## Mack Rides service bulletin relating to flume ride anti-roll back (ARB) components

| <b>Information Nr. / Bulletin No.:</b>              | SB 1985-1       |

| <b>Anlagenname / Ride name:</b>                                     | Flume Ride Tiger Rock, Chessington |

### Improvement of initial Anti-Rollback (ARB) components

rubber transportation belt

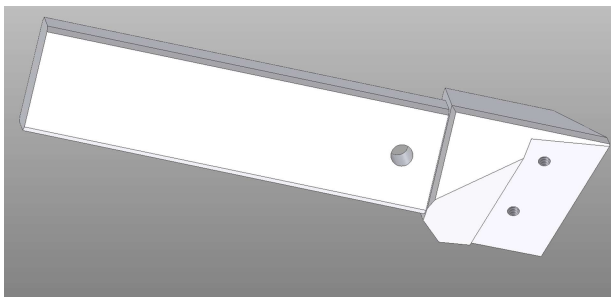
1, use qualified belt material from known manufacturers eg Continental or Dunlop only.

650 mm wide, EP 400/3, 3,5 : 3 mm cover

Normal Quality,

'Rufftop' surface

rod

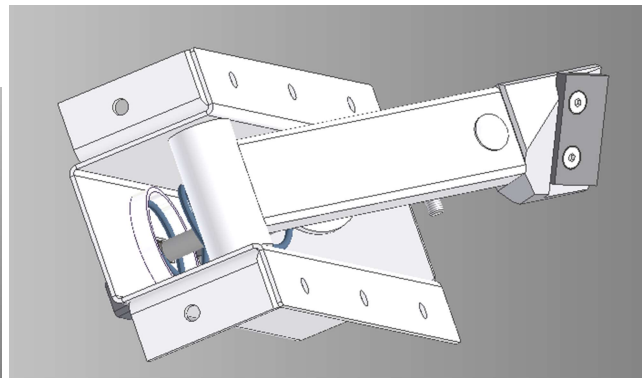
3, exchange the Polyamid rods of all the lateral flaps by the new design, in Aluminium and with an adapted geometry, see:

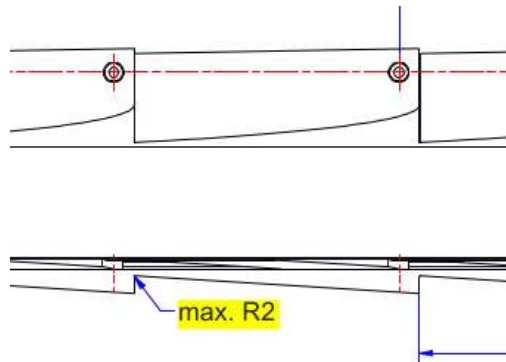
4, install two additional sets of flaps at the top of the lift crown.
